SHOP DRAWING REVIEW

DESCRIPTION: NEW DIAPHRAGMS

JOB: U.S. 2 OVER I-89

CASCO BAY STEEL STRUCTURES, INC.

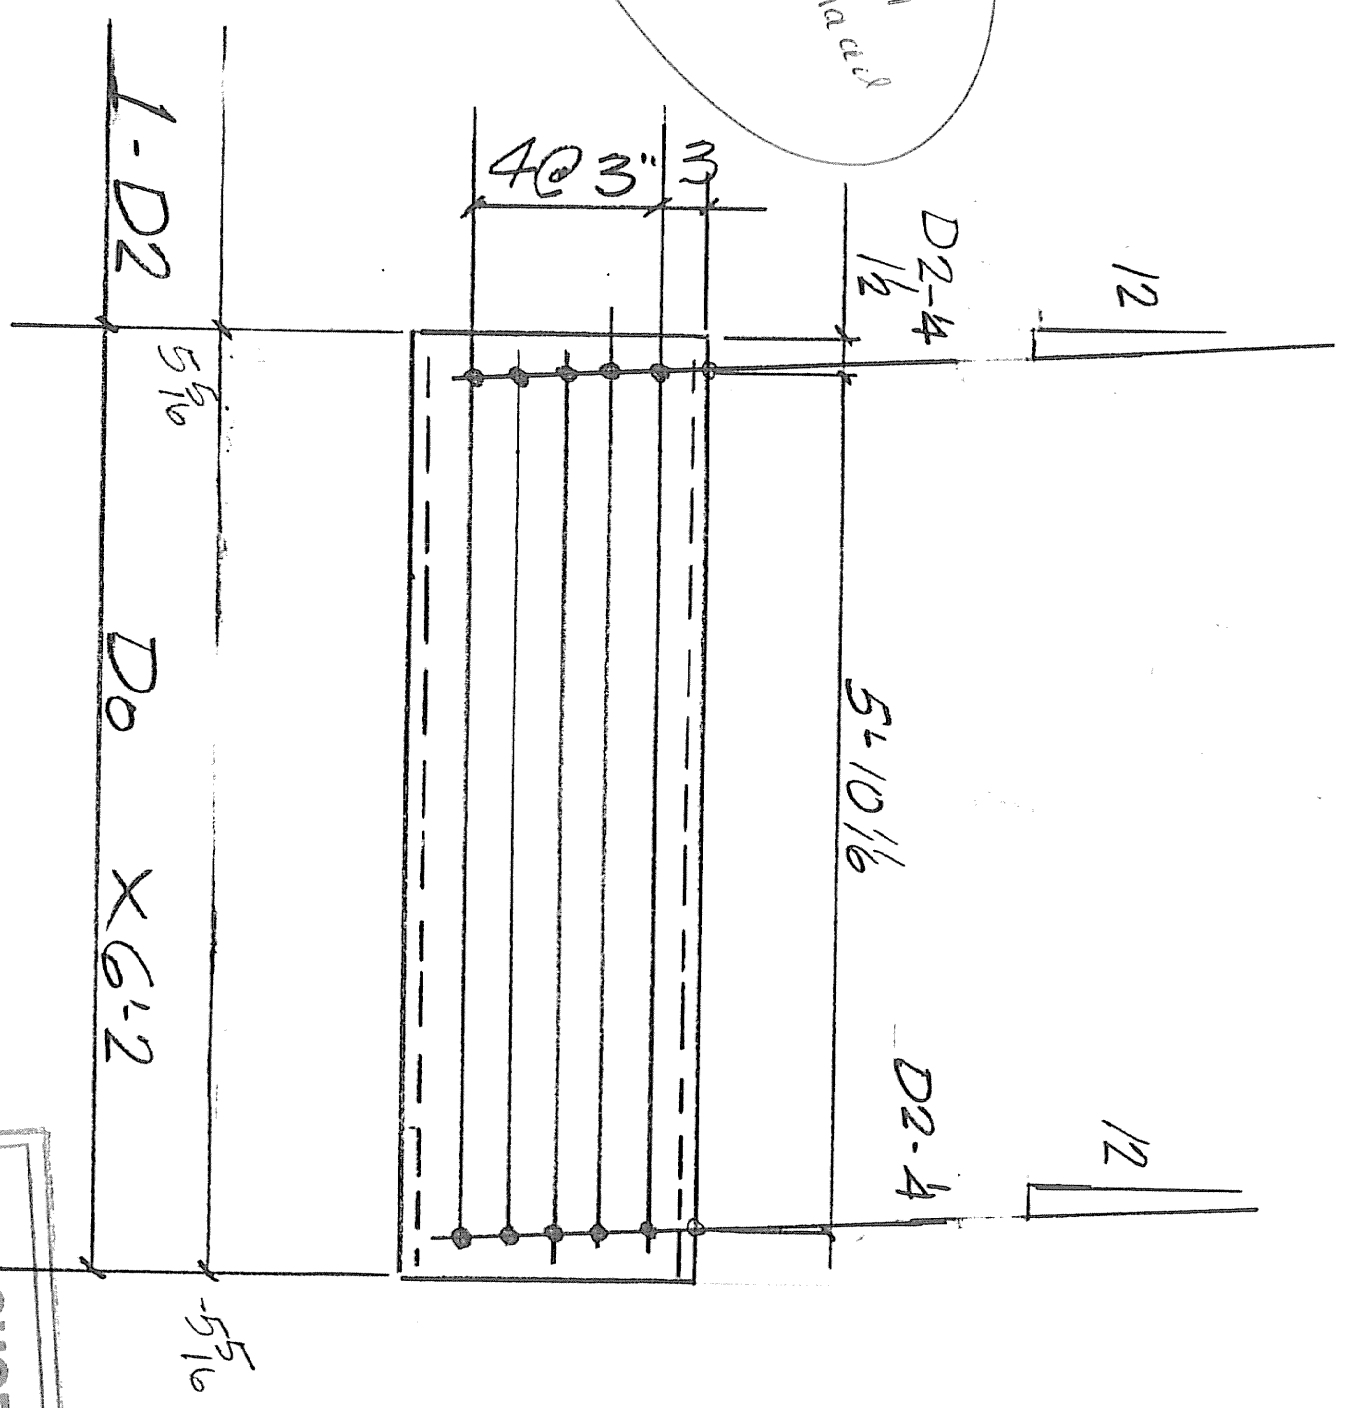
Robert Engineer on 3/11/01
only one diaphragm to be 30" in dia
